October 17, 2024

**Subject: 20195 Mack Ave (Branden McRill, Lola’s Taco Bar) Special Land Use and Site Plan Review**  
Parcel ID: 40-011-01-155-400  
Zoning: C - Commercial Business

# Special Land Use Review

# Site Plan Review

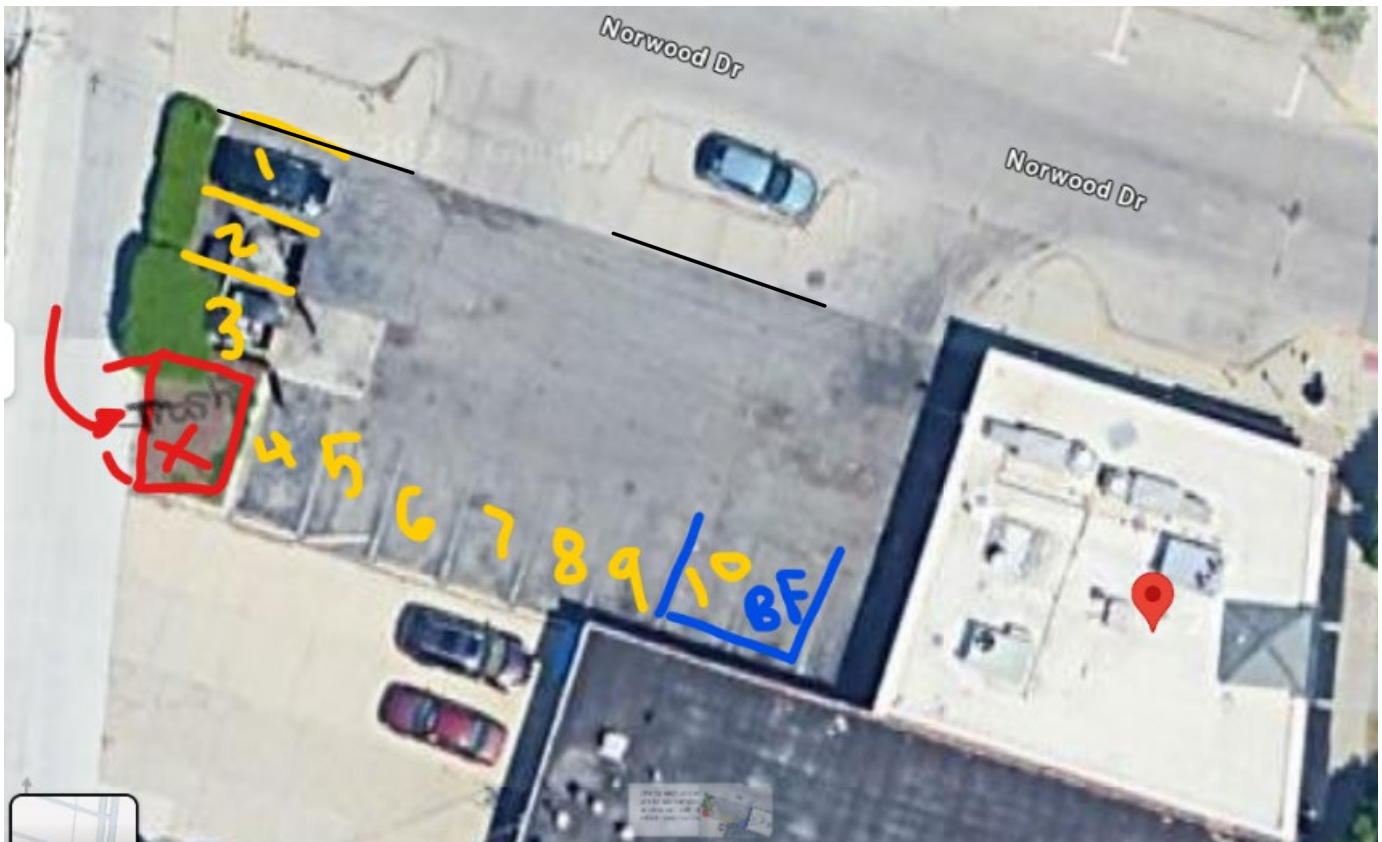
**Parking.** The current site configuration includes 10 parking spaces without any designated ADA spaces, which can be accessed via two egress/ingress drives off Norwood Drive. The applicant does not intend to modify the parking layout. Additionally, there are three on-street parking spaces along Norwood Drive and two along Mack Avenue that abut the property.

**Loading.** The site plans indicate the building as 2,192 square feet, which requires one loading space. The site plan does not indicate a dedicated loading and unloading zone. The applicant will need to give reason if a loading space is not needed, otherwise one must be added to the site.

**Protective Barrier.** The Ordinance requires that where a parking lot adjoins a public sidewalk, there shall a barrier so located as to prevent cars parked on such parking lot from extending over or encroaching upon such public sidewalk. **We recommend adding at least a two-foot tall masonry screening wall to prevent vehicles from extending over or encroaching on the sidewalk (the approximate areas are depicted in black on the image above).** If the applicant has substantial reasoning that a masonry screening cannot be accommodated in the space portrayed on the image below, in red, the Planning Commission may consider requiring a curb be added in place of the protective, screening wall barrier.

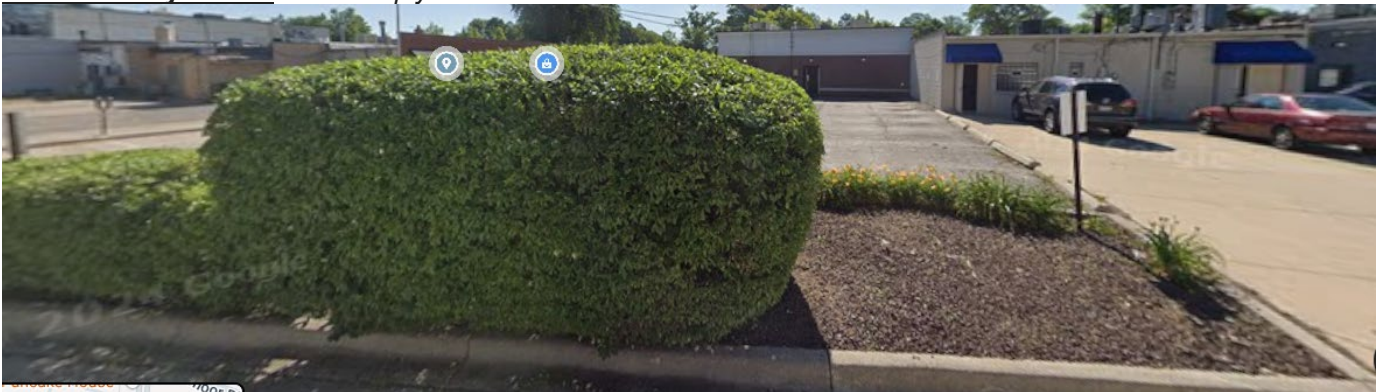
**Landscaping.** There is existing landscaping on site screening the parking lot from the residential properties behind the lot; however, the previous owner did not maintain the hedge well. The applicant has proposed to preserve the landscaping along the rear property line.

**Parking Lot Screening.** Whenever a parking area adjoins residential property or a residential street, an ornamental masonry wall not less than two feet or more than four feet in height shall be erected and maintained between the required yard space and area to be used for parking, except for such portions as are used for entrances and exits. The site currently utilizes a dense shrubbery screen in lieu of an ornamental masonry wall, that screens part of the length of the property. **Attention should be given to improve the shrubbery and prevent the shrubs from encroaching into the public alley and to complete the screening along the full length of the property line. Section 50-5.19 Greenbelts lists the plant types and species allowed as part of the shrubbery screen.** *Can comply.*
